# RESPONSE TO COMMENTS

## AREA 1 PHASE 1 DETAILED DEVELOPMENT PLAN BALTIMORE WORKS SITE, BALTIMORE, MARYLAND AUGUST 2013; REVISED DECEMBER 2013

### *MDE/SOLID WASTE PROGRAM COMMENTS AND RELATED RESPONSES*

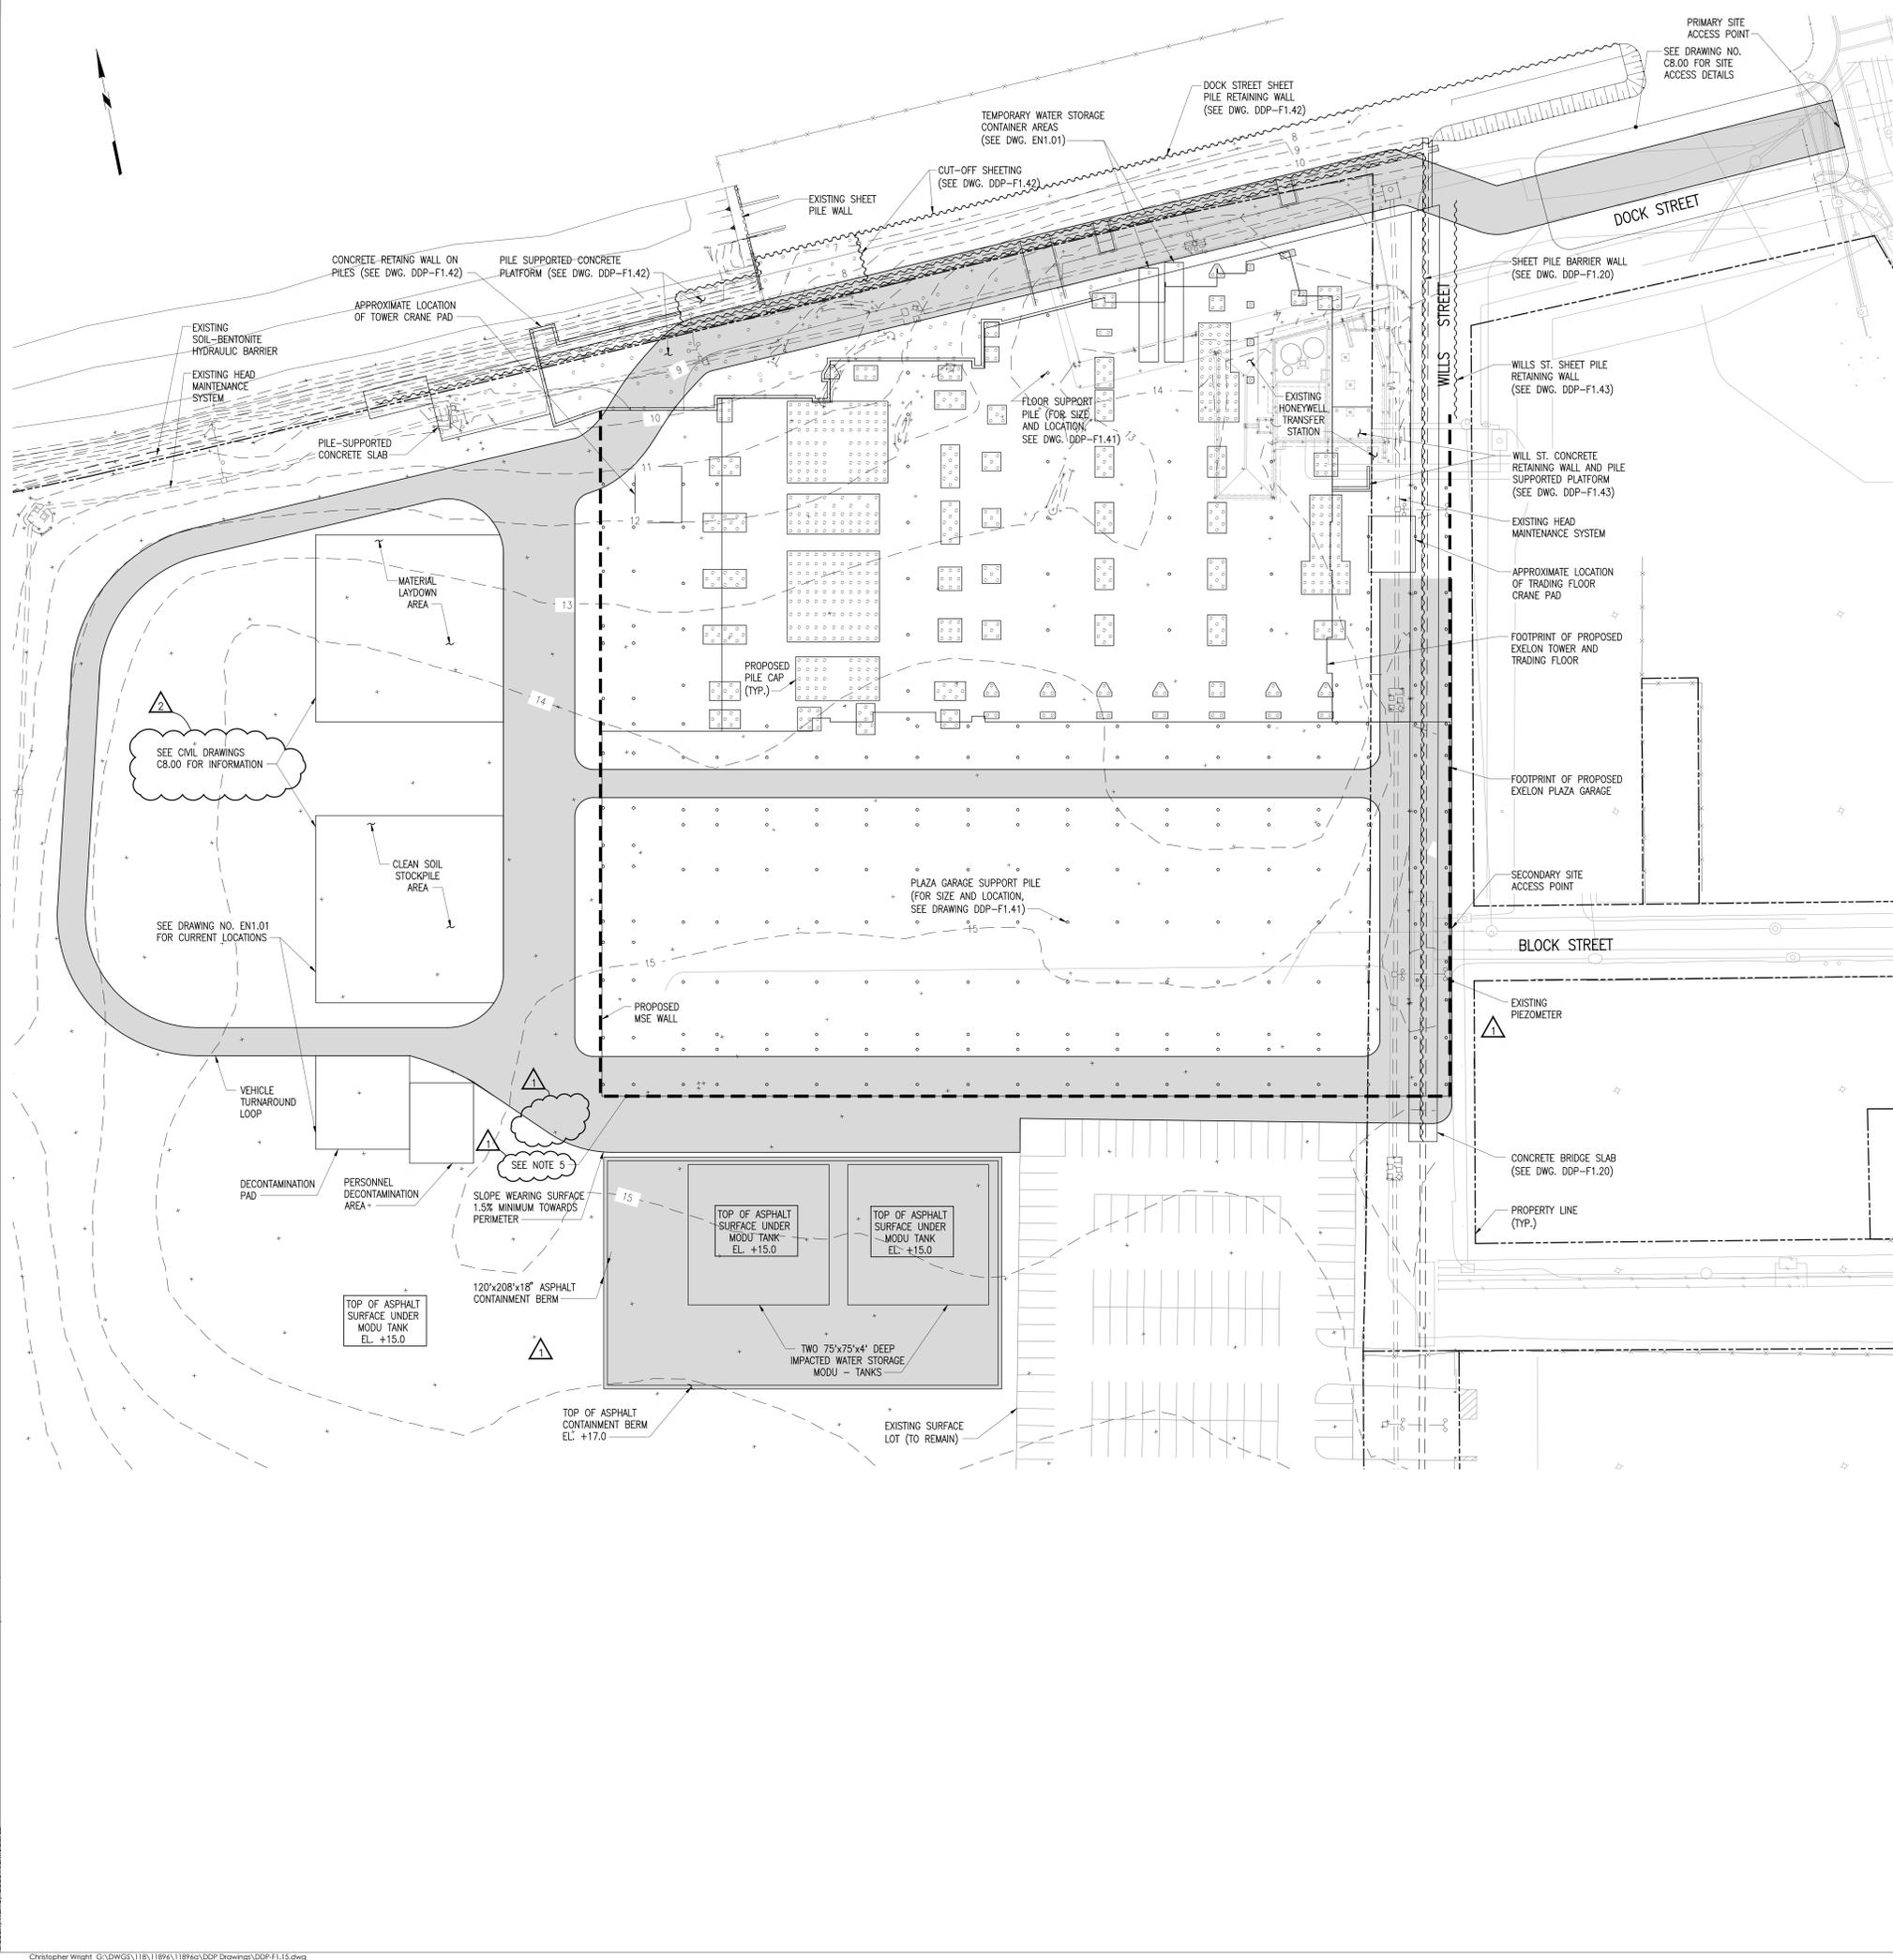
2. *EE cover letter – drawing F1.15 note 7 – it is unclear whether the note means that <16,000 ft<sup>2</sup> will be open only during a 100 year storm. The statement should specify that at no time*

*during the project will more than 16,000 ft<sup>2</sup> be open below the MMC.*

Acknowledged. The statement is changed to specify that at no time during the project will more than 16,000 ft<sup>2</sup> be open below the MMC. Drawing F1.15 attached.

- Vehicular speed must be less than 15 mph. Provide signage consistent with MDOT, road work construction standards.
  - For the storage volume shown, at any one time, the total area of excavations that drain beneath the MMC must be less than 16,000 square feet. Maintain water level in modutanks a minimum of 6 inches below capacity at all times.
